Subject: Work Plan for Pilot Study - Addendum
10700 MacArthur Boulevard
Oakland, California
AEI Project No. 261829
Toxics Case No. RO0002580

The ACHCS April 10, 2008 response letter contained 7 technical comments (shown by *italics* below), and AEI's response to each of these comments is included following the comment:

FIGURE 2
 PROJECT NO. 261829

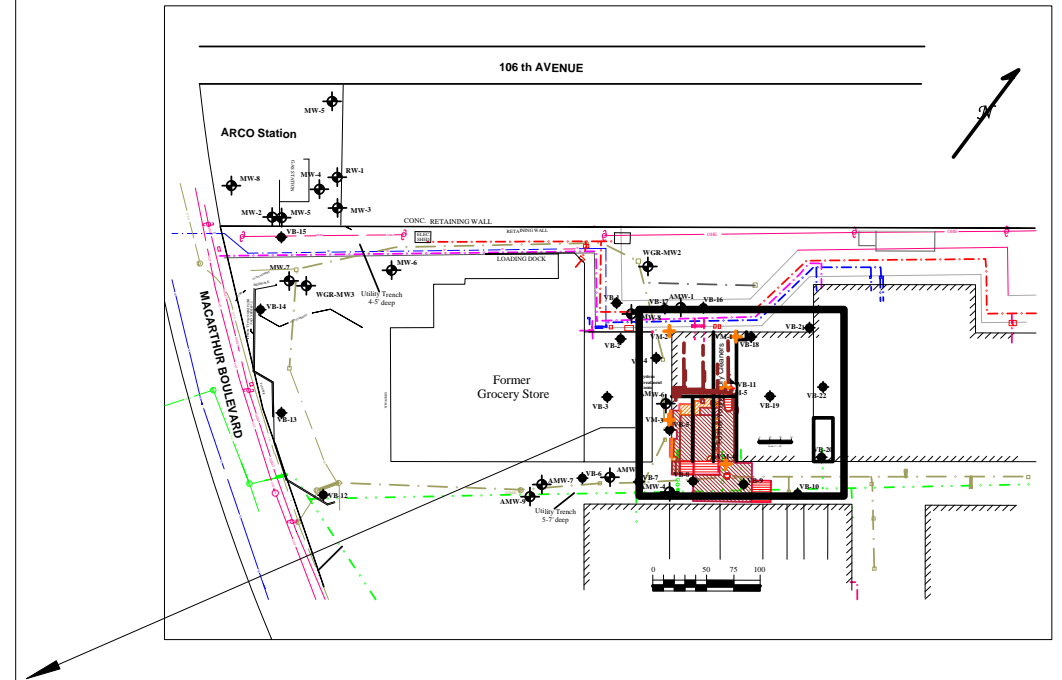
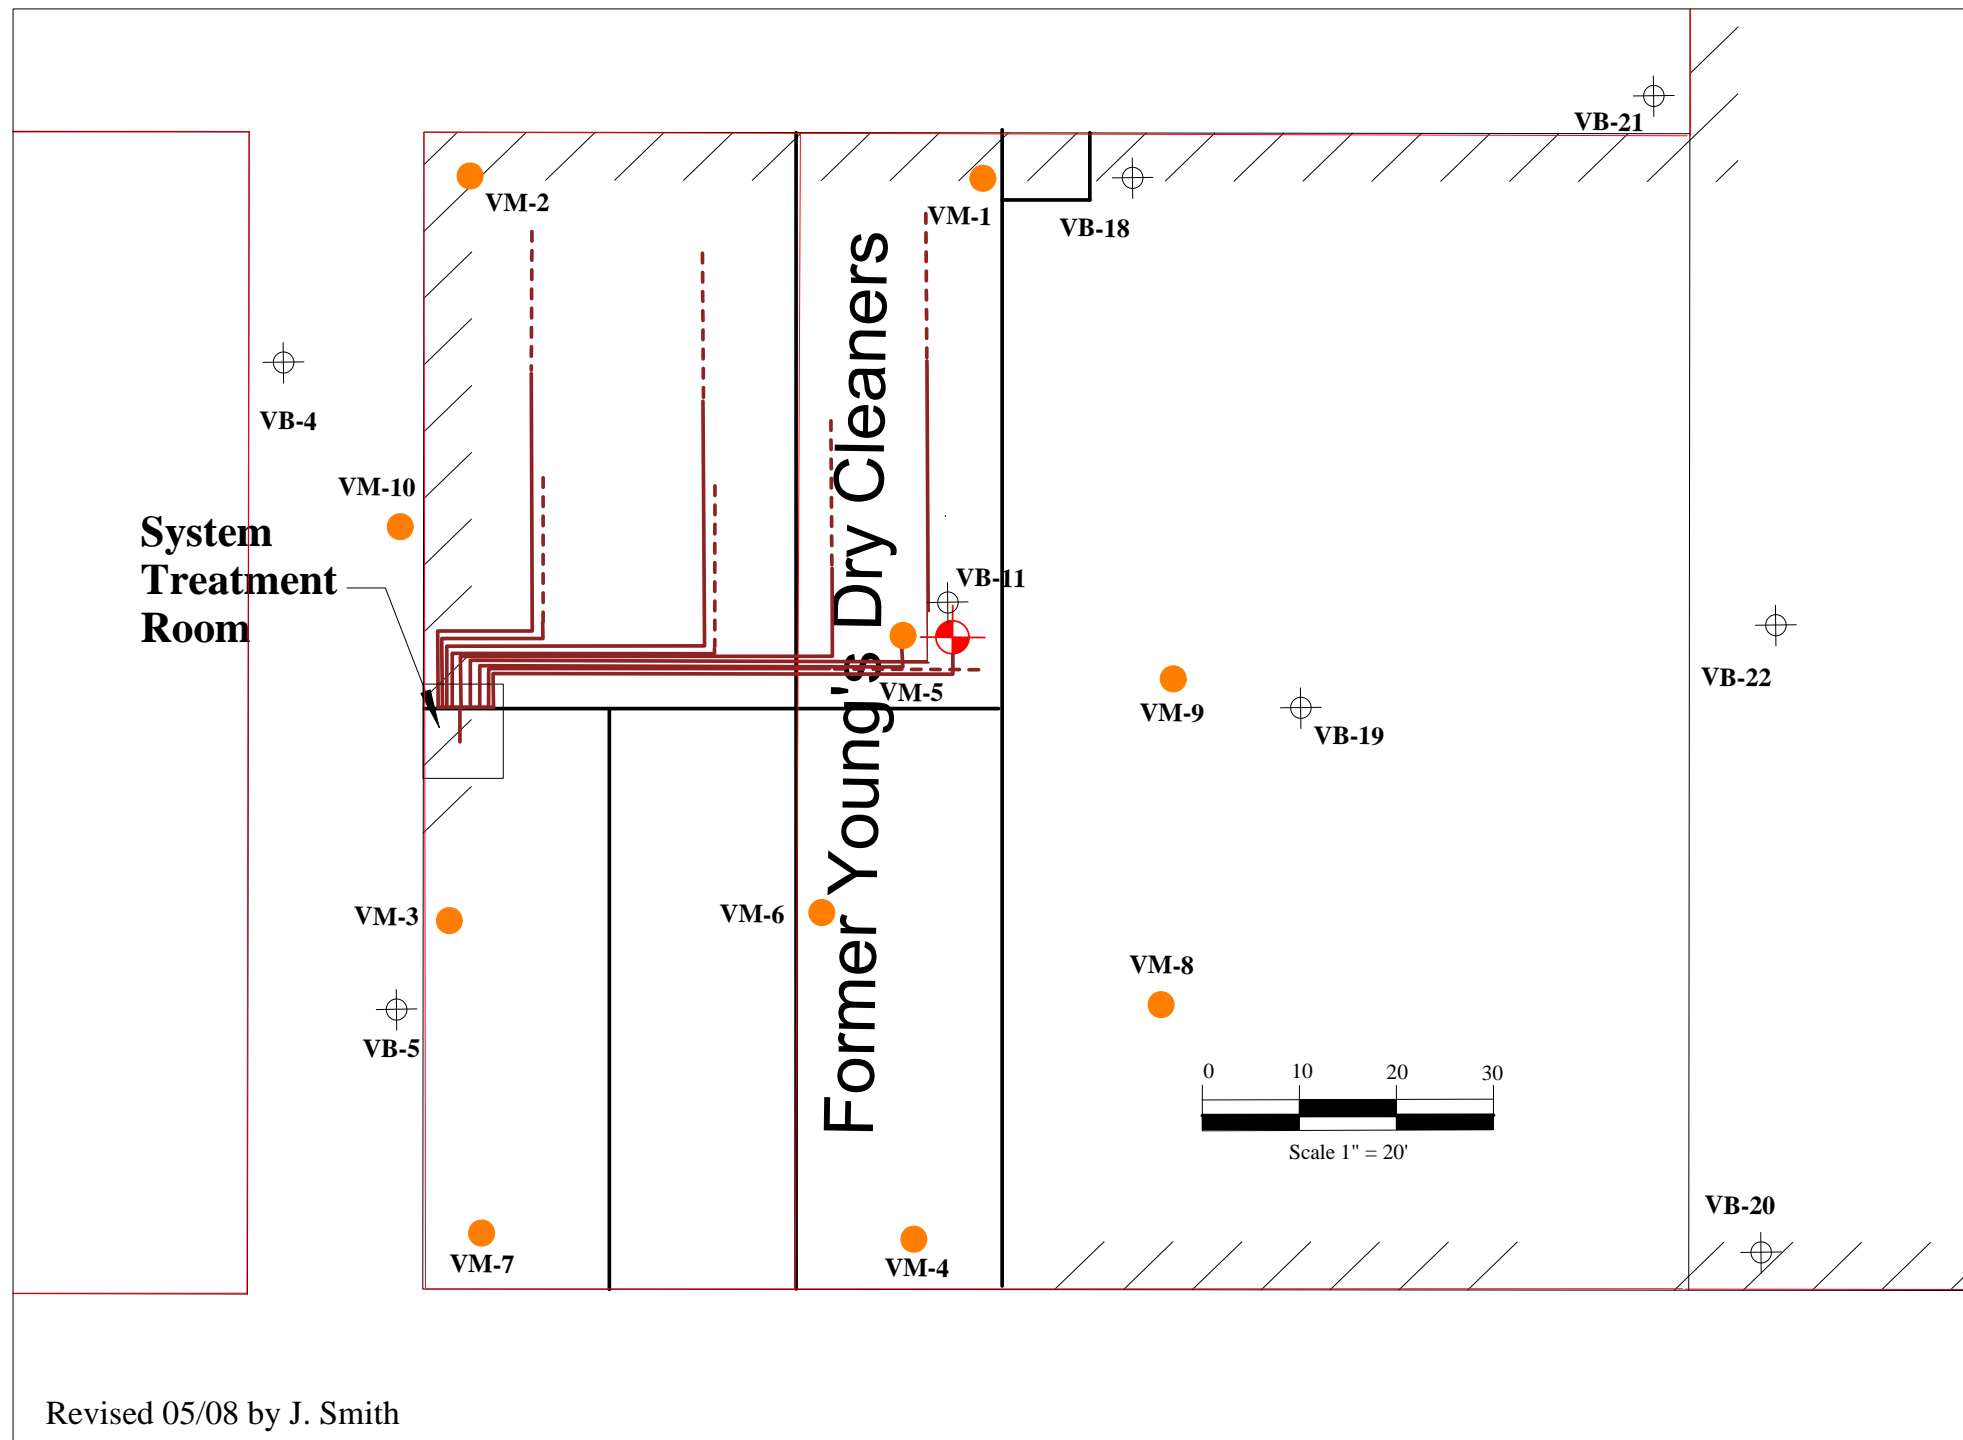
The ACHCS has requested further evaluation of soil vapor to the west of the subject site based on elevated concentrations in VB-3. In order to fully characterize the soil vapor to the west, AEI has proposed the installation of 2 additional soil vapor borings west of the site. The borings will be advanced to a depth of approximately 5 feet below ground surface (bgs), at which time a soil vapor sample will be collected and analyzed for halogenated volatile organic compounds (HVOCs) using EPA Method 8260. Soil vapor sampling will be conducted in accordance with DTSC standard protocol. Field procedures will be completed as previously performed and outlined in several investigation reports and workplans for the site; however as vapor intrusion is the concern at the site, AEI does not plan to collect soil vapor samples deeper than 10 feet bgs as has been previously performed.

7. Extent of VOCs in Vapor to South

Should analytical results indicate elevated HVOCs, AEI plans to advanced additional borings (labeled contingent) until the site has been fully characterized. Data will be compared to the appropriate environmental screening levels (ESLs) to determine the need to step out and complete contingent borings. The locations for the proposed and contingent borings are included on Figure 2. The additional soil vapor investigation is scheduled to occur in conjunction with the pilot testing activities, however is anticipated to be completed before construction activities have begun.

The ACHCS has requested further evaluation of soil vapor to the south of the subject site based on elevated concentrations in VB-8 and VB-9. In order to fully characterize the soil vapor to the south, AEI has proposed the installation of 2 additional soil vapor borings south of the site. The borings will be advanced to a depth of approximately 5 feet bgs and analyzed as described above. Should analytical results indicate elevated HVOCs, AEI plans to advanced additional borings (labeled contingent) until the site has been fully characterized. The location for the proposed and contingent borings is included on Figure 2.

4. Sub-Slab Monitoring

5. Building Space East of Former Young's Dry Cleaners

The ACHCS has requested that the location for the sub-slab monitoring probes be moved from outside the building foundation to inside the building foundation. The revised locations for the monitoring points, inside the building foundation (with the exception of VM-10), are included on Figure 3. Monitoring point VM-10 is located outside the foundation to verify if the radius of influence extends beyond the load bearing walls.

While it is noted that no elevated concentrations in soil vapor have been detected east of the former dry cleaner, the ACHCS has requested that additional monitoring points be installed east of the former Young's Cleaners to monitor soil vapor concentrations and system effectiveness east of the site. AEI has proposed two additional monitoring points (VM-8 and VM-9). The location of these points is shown on Figure 3.

APPENDIX A

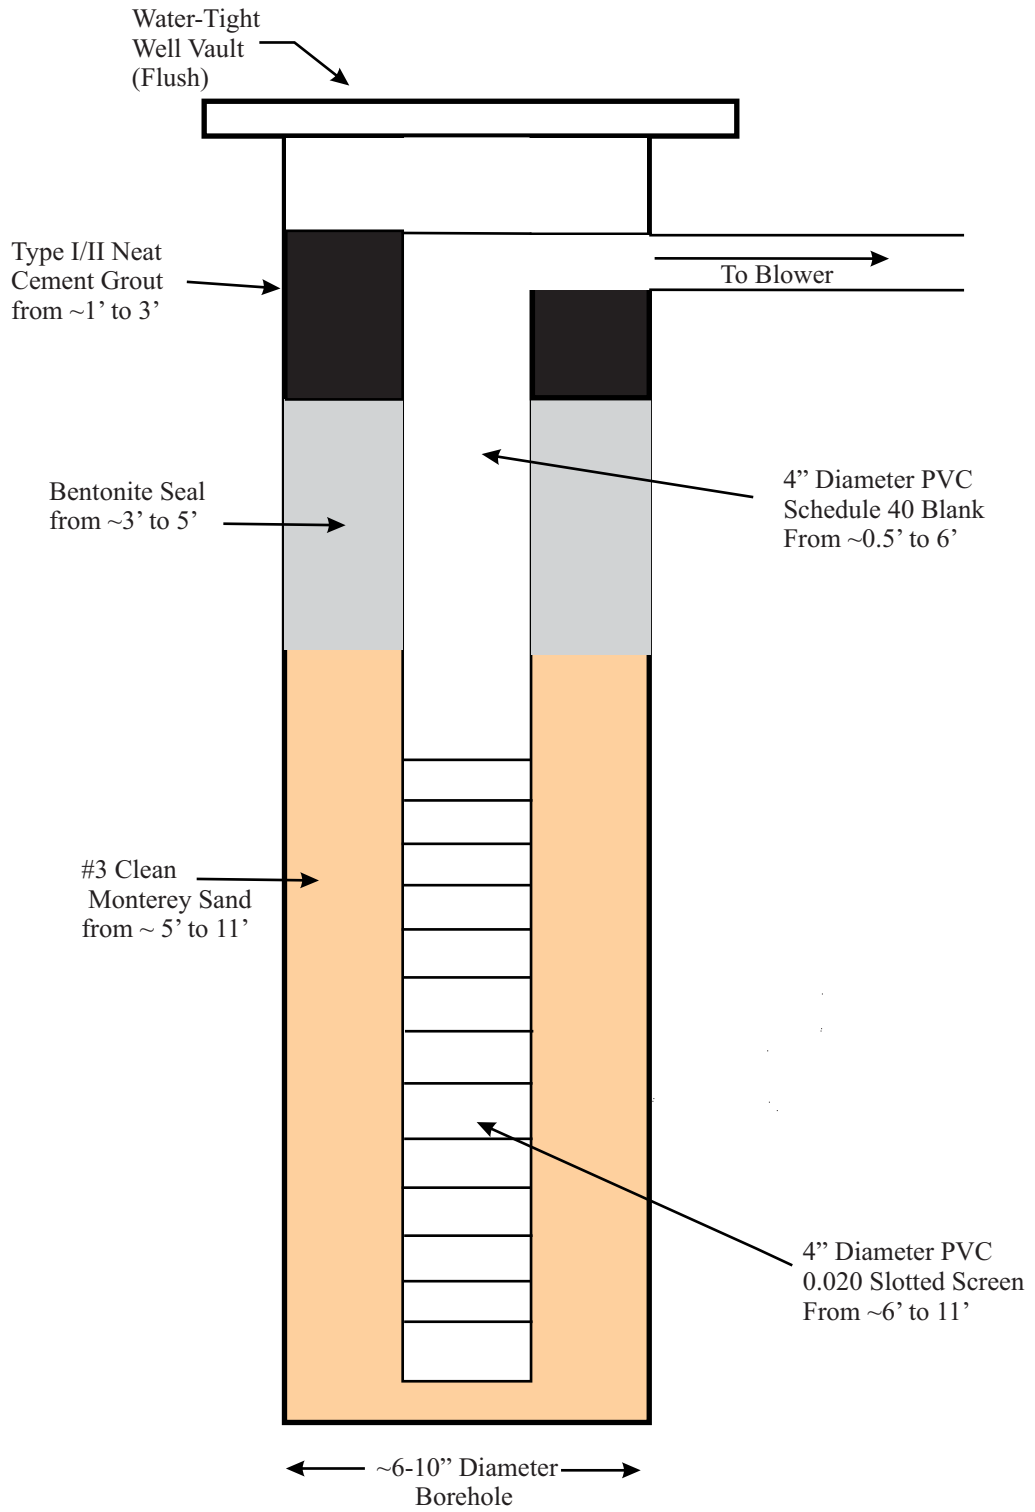
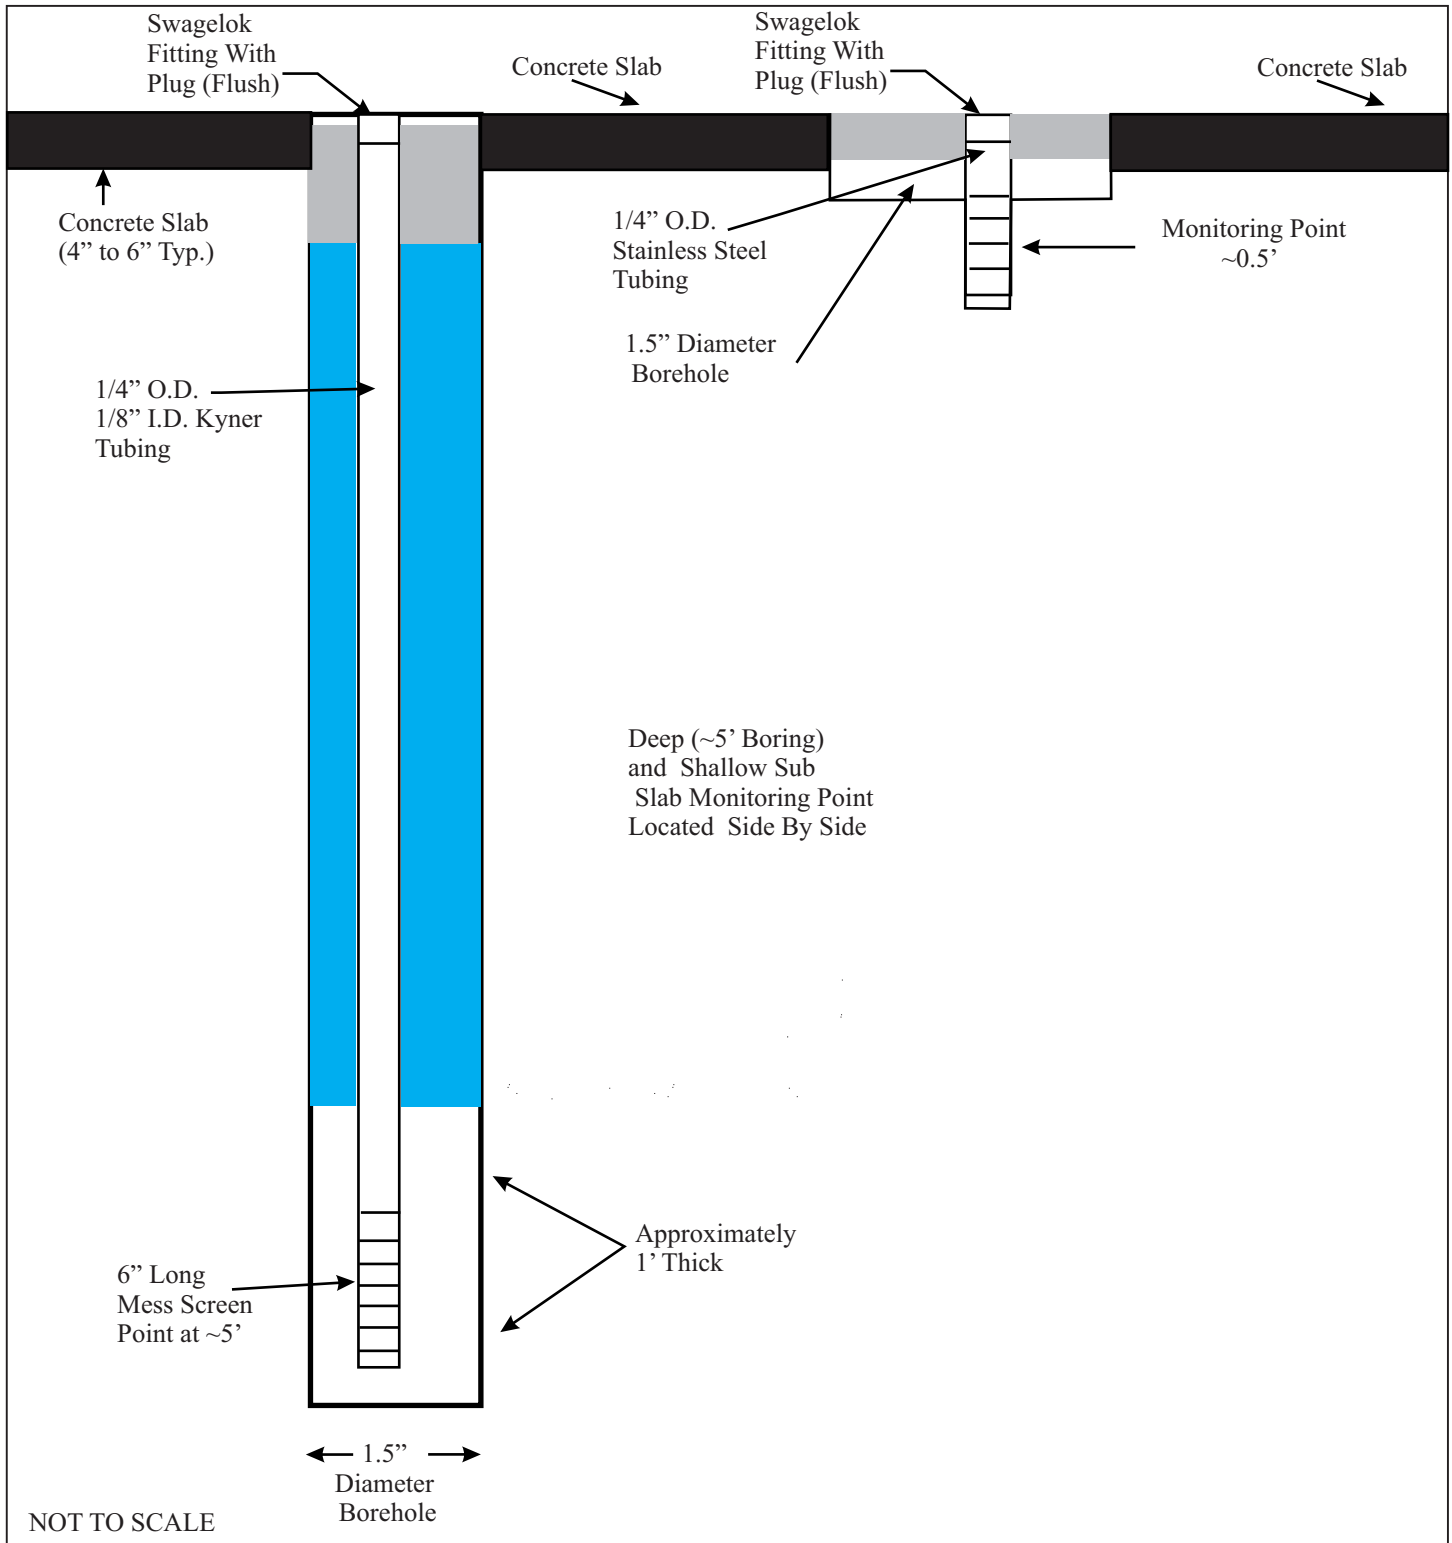
3. Extraction Well

The ACHCS has requested specifications of the proposed vapor extraction well at the site. The proposed specifications are included in Appendix A. In addition, the ACHCS has expressed concern on how the vapor monitoring points will be installed to prevent air flow between the building and the sub-slab. The top of each monitoring point, coinciding with the existing concrete slab, will be completed with Type I/II neat cement grout in order to fully seal the top of the sampling port. The top of the sampling points will include Swagelok fittings for easy sampling access which will be set within the neat cement. A Swagelok plug will be installed when the points are not being sampled. Diagrams for the sampling points, as well as a photograph of a completed vapor monitoring probes, are included in Appendix A.
